Report: TAB REPORT
Function: Test, Adjust, & Balance
Date: 07/24/2023

06-24-24 WALGREENS #1769 - DENVER, CO

Project: 06-24-24 WALGREENS #1769 - DENVER, CO

EF2_DROP
07/25/2023

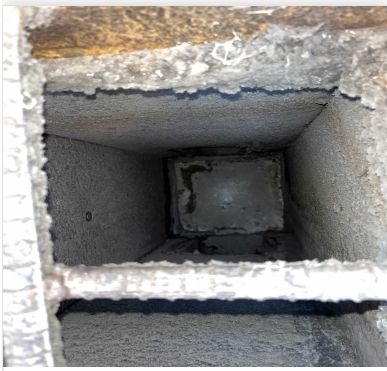
Issue Name : EF2 No Backdraft Damper
Description : No backdraft damper was found in the EF2 ductwork. Recommend installing to prevent drafting into the restrooms when the fan is not running.
Created By : National TAB **Assigned To :** National TAB - Stephen Tassinaro
Status : Open
Priority : Medium **Asset Tag :**
Originated Date : 07/25/2023 - Stephen Tassinaro - National TAB

- **06/17/2024 National TAB - Stephen Tassinaro**
 - No damper installed.

EF3
07/25/2023

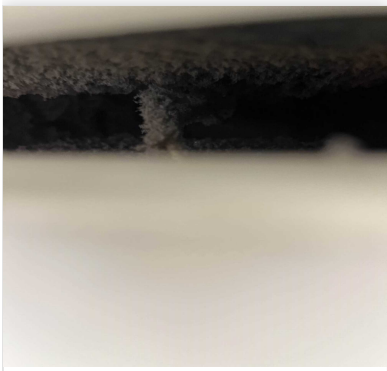
Issue Name : EF3 Dirty and Low Flow
Description : EF3 in the employee room is exhausting 30CFM out of 100CFM design. Fan found to be functional but clogged with dirt and debris. Thorough cleaning recommended.
Created By : National TAB **Assigned To :** National TAB - Stephen Tassinaro
Status : Open
Priority : **Urgent** **Asset Tag :**
Originated Date : 07/24/2023 - Stephen Tassinaro - National TAB

- **06/19/2024 National TAB - Stephen Tassinaro**
 - Airflow is now reduced to 0CFM, fan is still operating but flow hood is unable to detect any airflow. Fan is very dirty. It is possible a larger fan need be installed to overcome to rise to the rooftop from the basement, as well as thoroughly cleaning the duct.

Dirty_Filters
06/19/2024

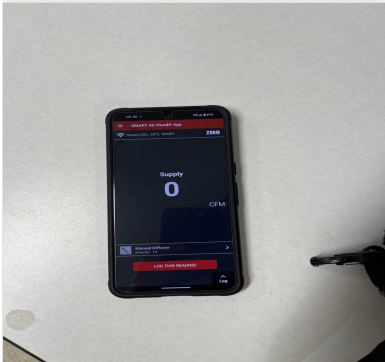
Issue Name : RTU Final Filters
Description : Recommended to install the appropriate sized MERV 8 or better throwaway filters in the RTUs for improved filtration.
Created By : National TAB **Assigned To :** National TAB - Stephen Tassinaro
Status : Open
Priority : Medium **Asset Tag :**
Originated Date : 07/20/2023 - Stephen Tassinaro - National TAB

- **06/17/2024 National TAB - Stephen Tassinaro**
 - MERV 8 filters now installed in all units, but they are dirty and due for replacement.
